RE: APPLICATION TO CHANGE A PDA DEVELOPMENT APPLICATION PURSUANT TO SECTION 99 OF THE ECONOMIC DEVELOPMENT ACT 2012 FOR DEVELOPMENT PERMIT FOR A MATERIAL CHANGE OF USE FOR MULTIPLE DWELLING (114 TOWNHOUSES) UPON LAND AT 1 CLARKE STREET, SOUTHPORT (EDQ REF: DEV-2026-GCP-4381)

AMENDMENT APPLICATION

Figure 5: Proposed Managers Office Location, Before - Left, After - Right

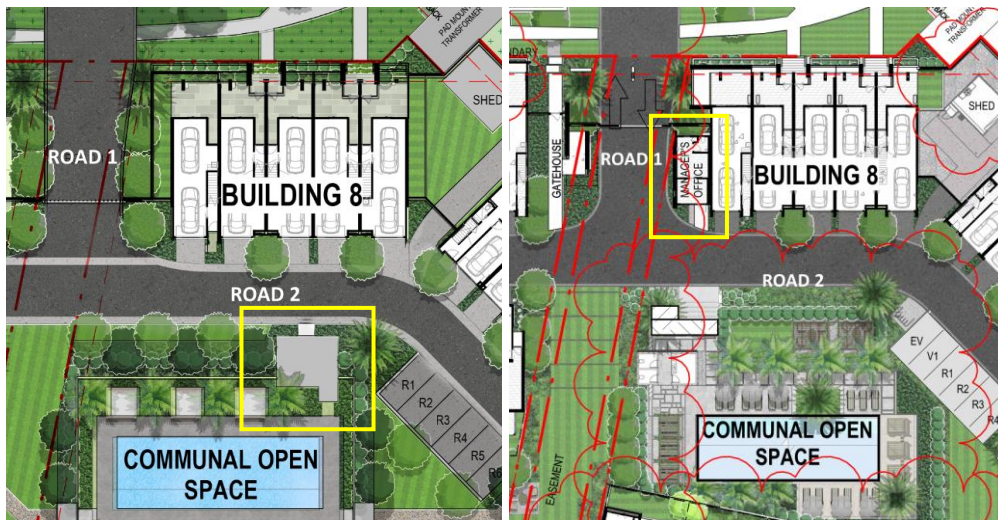
As previously discussed with Council officers, this application seeks to explicitly reflect the manager's office as a separately titled lot, resulting in a total of 115 lots together with the communal Lot 0 upon registration of the future Building Format Plan.

As part of the redesign of the communal open space, the manager's office has also been relocated to adjoin Building 8 rather than being positioned within the communal open space. This amendment has no material planning implications and is considered to have negligible impacts on the operation, appearance or functionality of the development.

Figure 8: Village Boulevard/Clarke Street Urban Marker, Before (subject to condition changes) – Left, After – Right

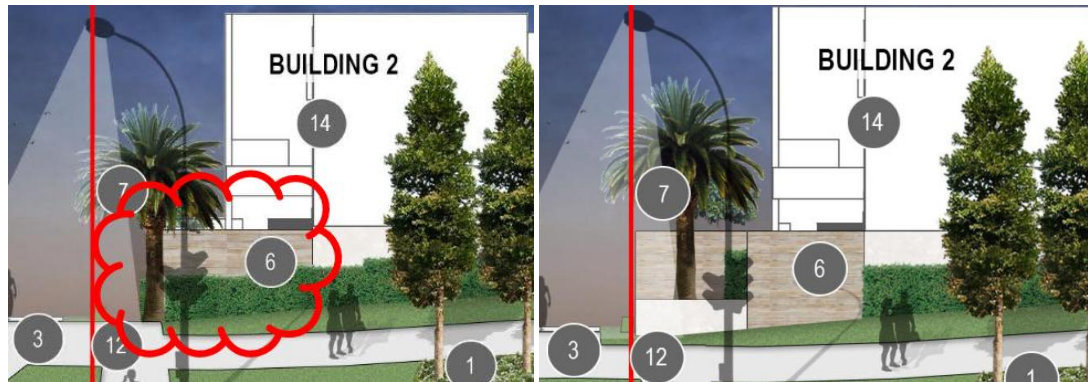
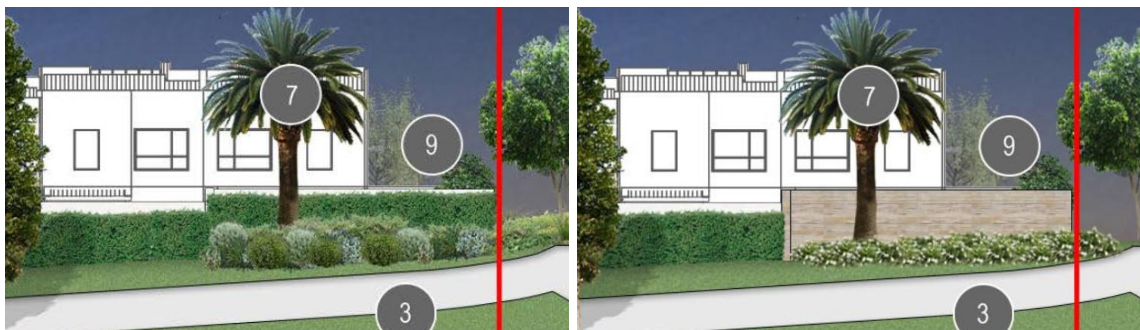
The landscape treatment at the corner of Smith Street and Village Boulevard has been revised to better showcase the approved feature brick walls forming the site's primary urban marker, consistent with previous in-principle agreement with EDQ officers.

The previously approved hedge planting has been removed, allowing the architectural brick elements to become the defining feature at this prominent corner, complemented by the feature palm planting. The revised treatment provides a stronger sense of arrival and identity for the development and represents an improved streetscape outcome.

Figure 10: Approved vs Proposed Staging Plan

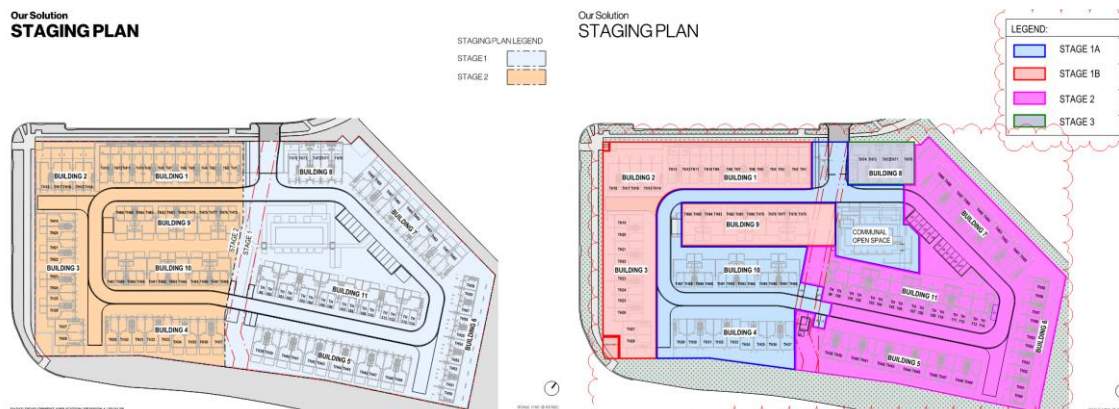
Following further construction planning and programming, the staging plan has been revised to facilitate a more efficient delivery of the development.

As illustrated above, the approved two-stage construction sequence has been refined into four stages. Importantly, the proposed Stage 1A and Stage 2 continue to operate independently in the same manner as contemplated by the approved staging arrangement, ensuring each stage remains fully functional. The introduction of intermediate Stages 1B and 3 provides greater flexibility in construction sequencing, enabling more efficient project delivery without altering the ultimate development outcome or creating additional planning impacts. Further to the above, the revised staging arrangement has been configured with supporting assessment from *QTraffic*. Please refer to **Attachment 3 – Traffic Statement**, prepared by *QTraffic* for further information.

Figure 13: Proposed Ground Floor

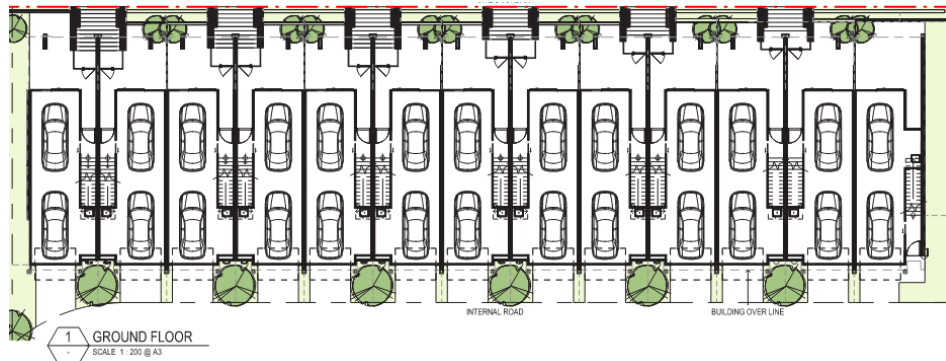
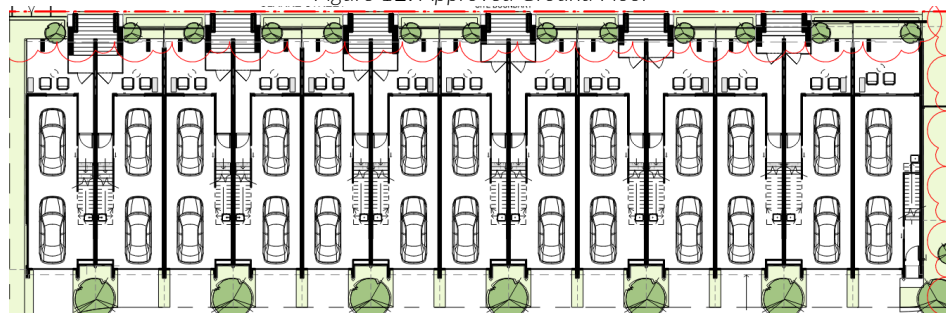
- Added a water meter box within the landscape area adjacent to Building 1 TH13.
- Revised balcony façade wall design and introduced a blade wall.
- Changed the master bedroom door from a sliding door to a hinged swing door.
- Added feature recess joints to building façades to assist in reducing perceived bulk.
- Introduced a render blade to the left-hand end condition, continuing the blade language from the internal elevation (on the internal side of the axon cladding).
- Revised façade materials, including swapping sections to FC board and batten cladding to improve verticality and assist in breaking up the façade.
- Revised first-floor glazing types and dimensions.
- Relocated townhouse numbering.
- Realigned glazing to improve overall façade aesthetics.
- Enhanced the Clarke Street entry gate design.
- Revised façade junction wall design.

3.4 Building 2 – 'Portavilla'

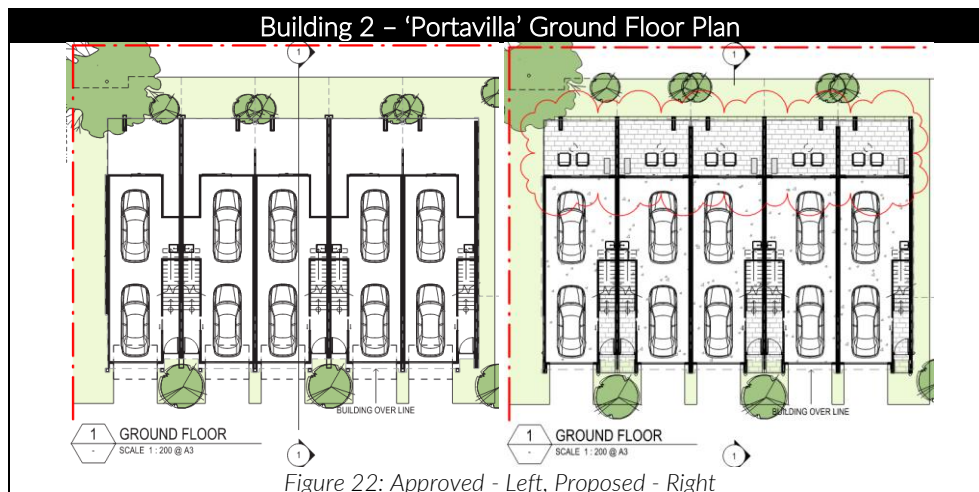
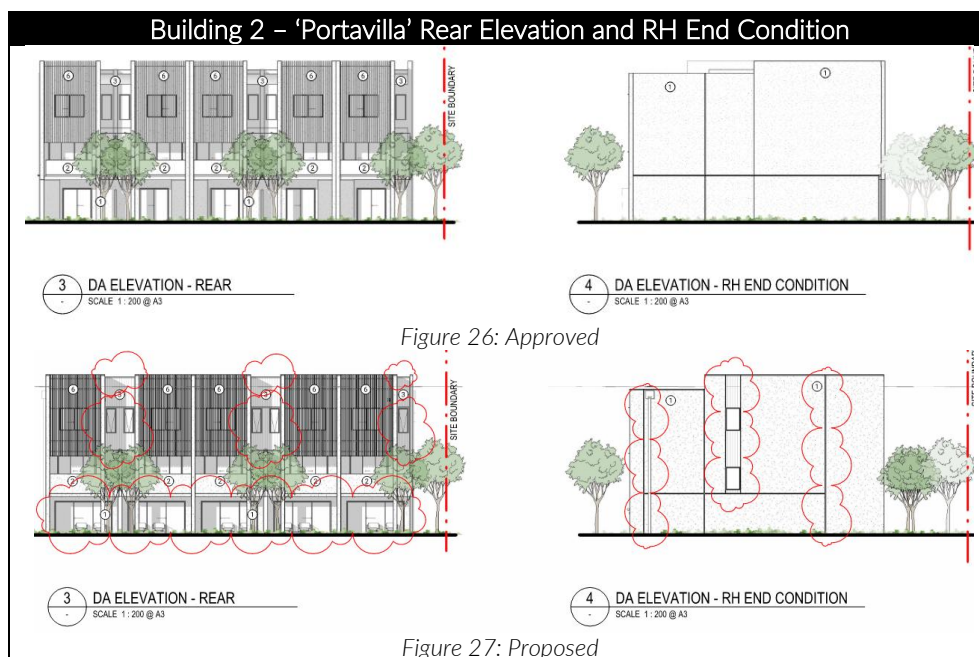
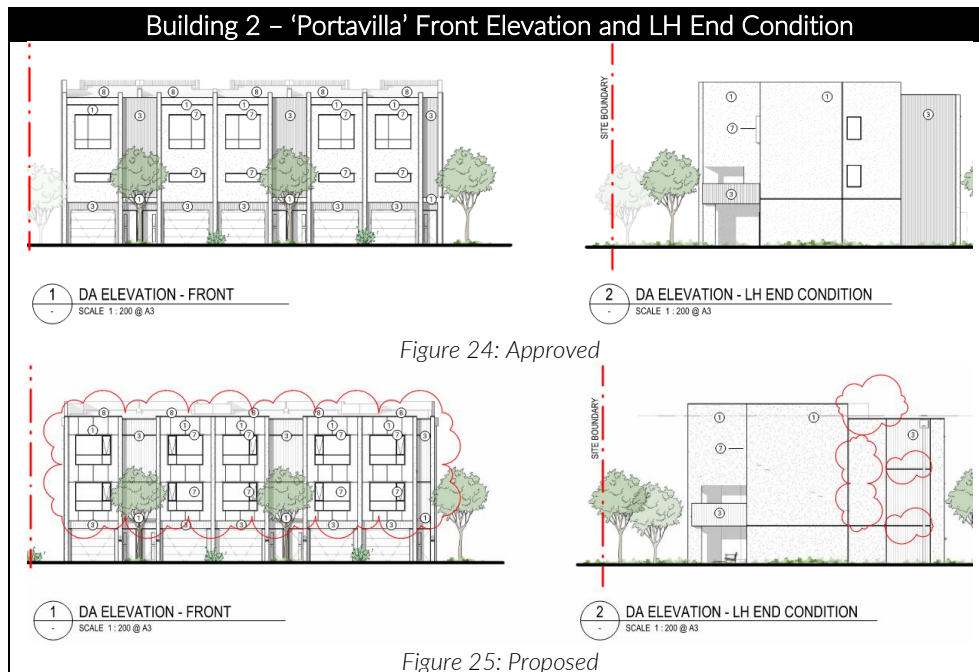
- Revised the A2 floor plan by removing the recess and increasing garage size.
- Replaced the two-panel sliding door with a three-panel sliding door.

- Revised balcony façade wall design.
- Changed the master bedroom door from a sliding door to a hinged swing door.
- Changed internal façade treatment to board and batten cladding to improve vertical design aesthetics and assist in breaking up the façade.

- Revised first-floor glazing types and dimensions.
- Relocated townhouse numbering.
- Added feature recess joints to building façades to assist in reducing perceived bulk.

- Removed windows from the Village Boulevard side façade where they did not align with the internal floor plans.
- Introduced a render blade to the left-hand end condition, continuing the blade language from the internal elevation (on the internal side of the axon cladding).

- Added windows to the right-hand end condition to align with updated floor plans.
- Reduced variation in rear parapet heights.

3.5 Building 8 ‘Portavilla’

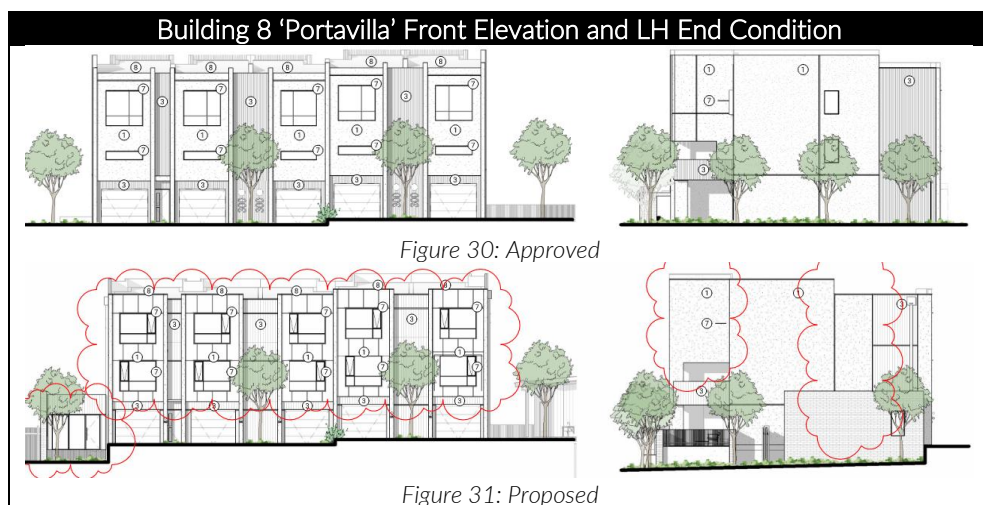
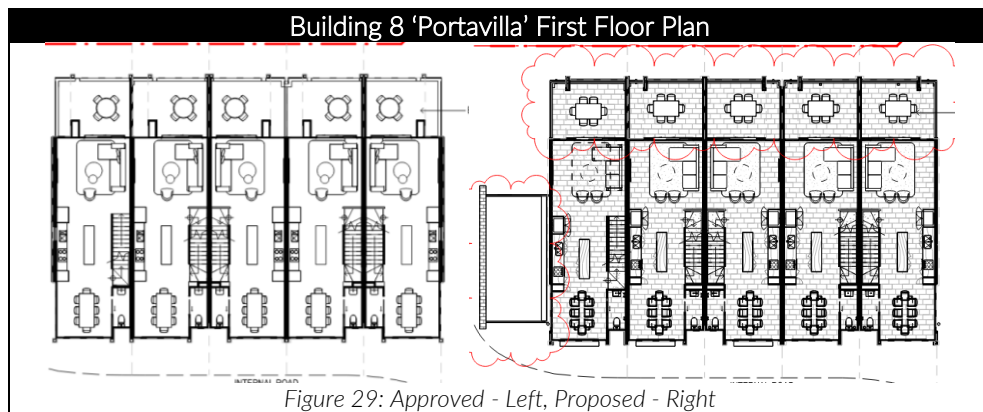
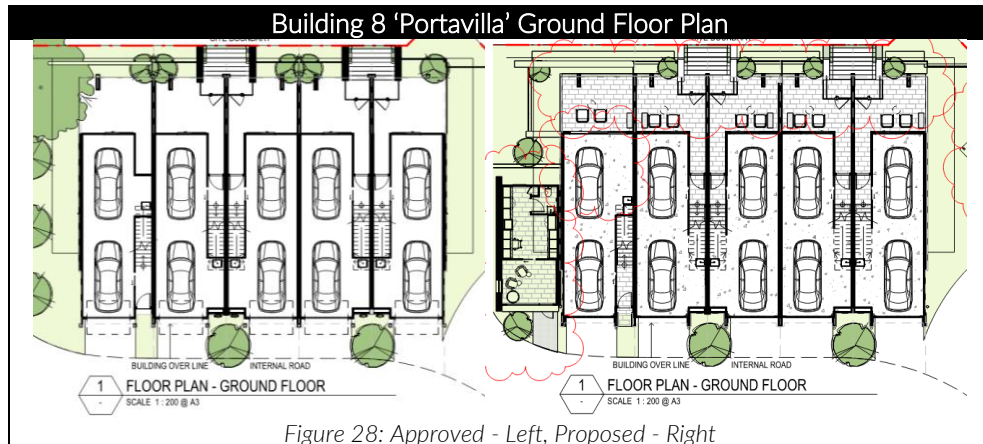
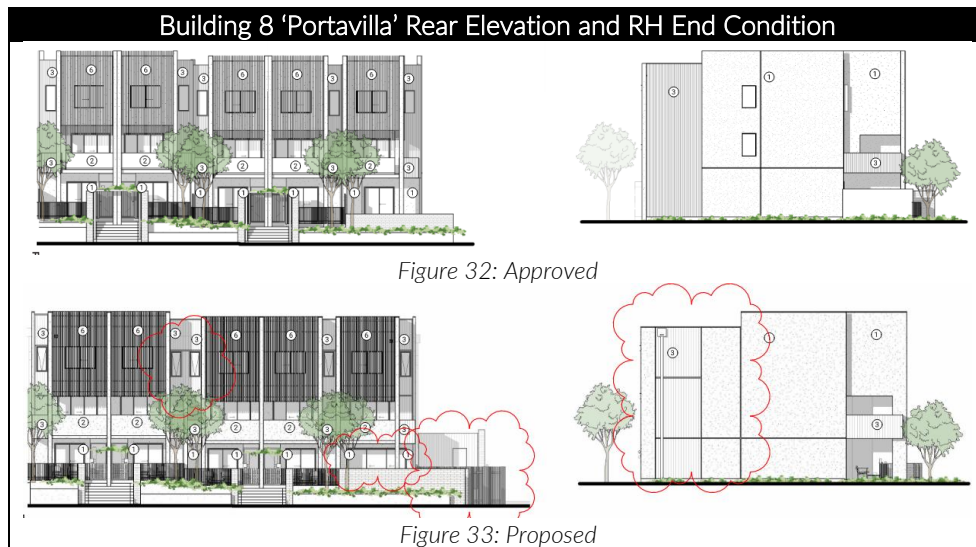
- Revised the A2 floor plan by removing the notch and increasing garage size.
- Replaced the two-panel sliding door with a three-panel sliding door.
- Revised balcony façade wall design.
- Changed the master bedroom door from a sliding door to a hinged swing door.
- Changed internal façade treatment to board and batten cladding to improve vertical design aesthetics and assist in breaking up the façade.
- Revised first-floor glazing types and dimensions.
- Relocated townhouse numbering.
- Added feature recess joints to building façades to assist in reducing perceived bulk.
- Removed windows from the Village Boulevard side façade where they did not align with the internal floor plans.

- Introduced a render blade to the left-hand end condition, continuing the blade language from the internal elevation (on the internal side of the axon cladding).
- Realigned glazing to improve overall façade aesthetics.

Figure 35: Proposed

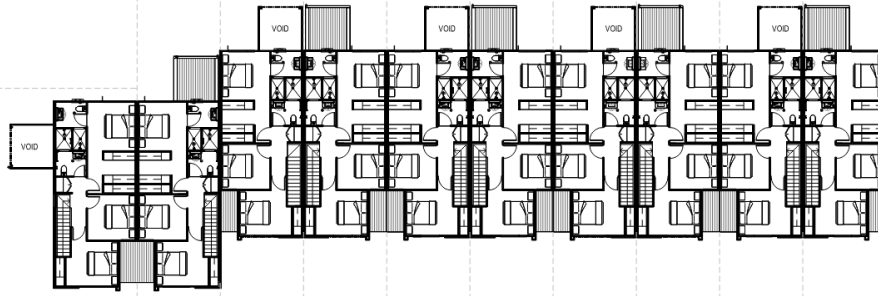
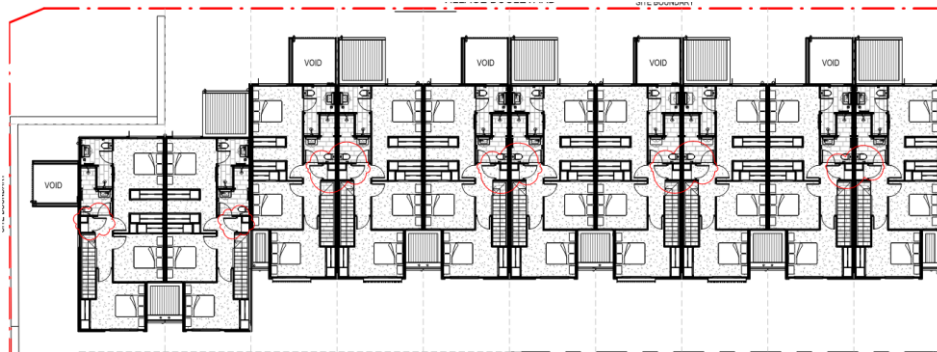
- Revised toilet layout to comply with Livable Housing Design Standards.
- Changed storage door to a hinged swing door.
- Removed slimlite glazing profile from front entry door (side light window retained).
- Reduced townhouse numbering size to improve human-scale presentation.
- Amended parapet alignment to achieve greater consistency.
- Revised window types and relocated awning panels to improve functionality and consistency.
- Added additional steps to side parapets on both sides of the building.
- Added building rebate joint details to end conditions.
- Reduced rear elevation window sizes to achieve consistent internal sill heights.
- Introduced a new ground-floor window.
- Added additional FC cladding to the Village side of TH28 to reduce façade bulk.

Figure 58: Proposed

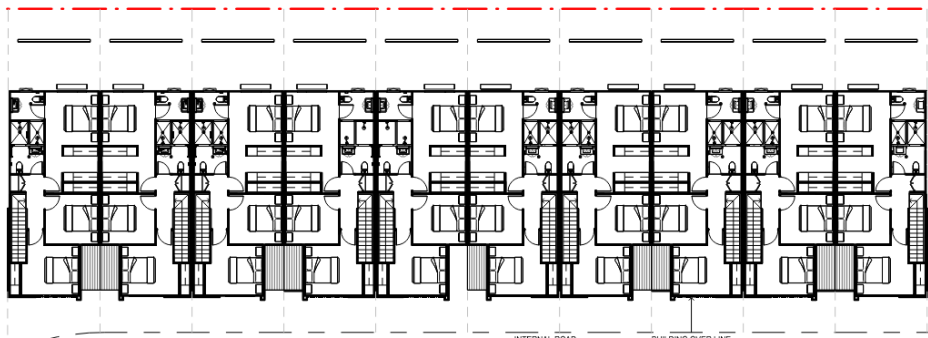
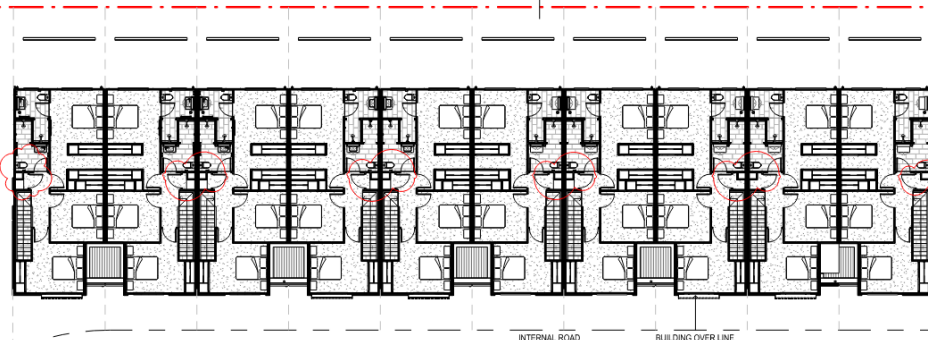
- Revised toilet layouts to comply with Liveable Housing Design Standards.
- Changed storage doors to hinged swing doors.
- Removed slimlite glazing profile from front entry doors (side light windows retained).
- Reduced townhouse numbering size to improve human-scale presentation.
- Amended parapet alignment to achieve greater consistency.
- Revised window types and relocated awning panels to improve functionality and consistency.
- Added additional steps to side parapets on both sides of buildings.
- Added building rebate joint details to end conditions.
- Revised window types.

Figure 68: Proposed

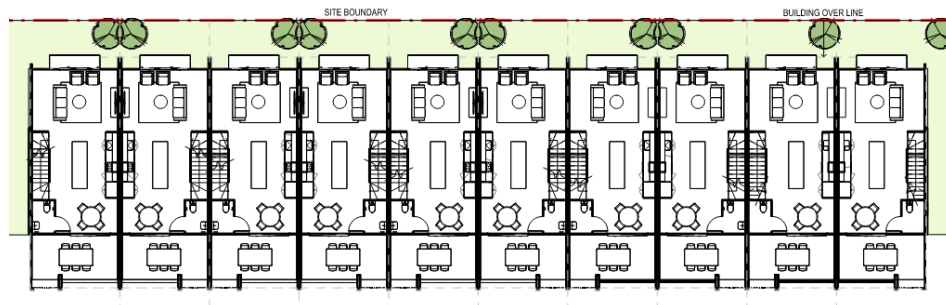
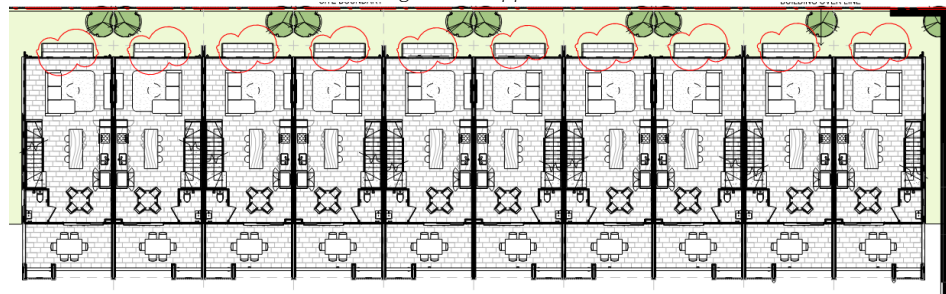
- Updated landscape design.
- Relocated retaining walls by 150mm to accommodate lightweight wall construction.
- Introduced window hoods.
- Revised second-floor layout to provide additional storage and study area.
- Changed cladding around garage doors, level 1 balcony sliding doors and behind batten screens from render to FC cladding to reduce perceived bulk.
- Added townhouse numbering.
- Revised location of building steps within side elevation parapets on both sides.
- Added rebate joint details to end conditions.
- Revised window types and sliding door dimensions.

Figure 94: Proposed

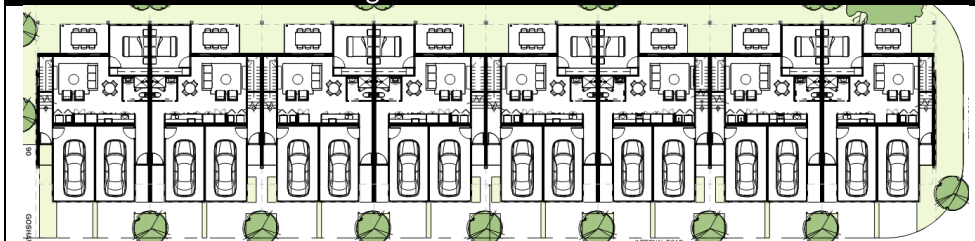
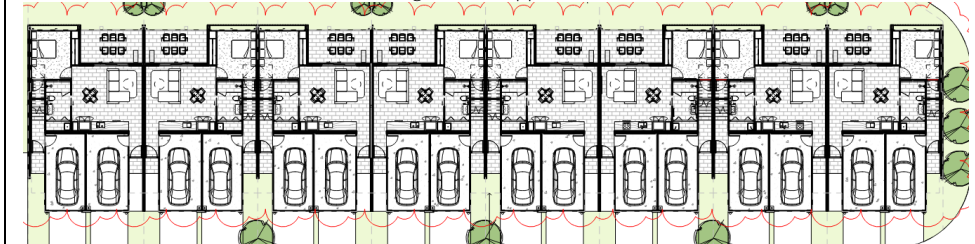
- Revised building layout, resulting in minor façade changes and improved privacy outcomes adjacent to communal open space areas.
- Amended parapet alignment to achieve greater consistency.
- Revised window types.
- Introduced shadow line detailing.
- Added townhouse numbering.
- Revised end elevations on both sides to align with updated floor plans.
- Added additional feature recess joints to building façades to assist in reducing perceived bulk.
- Revised rear elevation to align with updated floor plans.
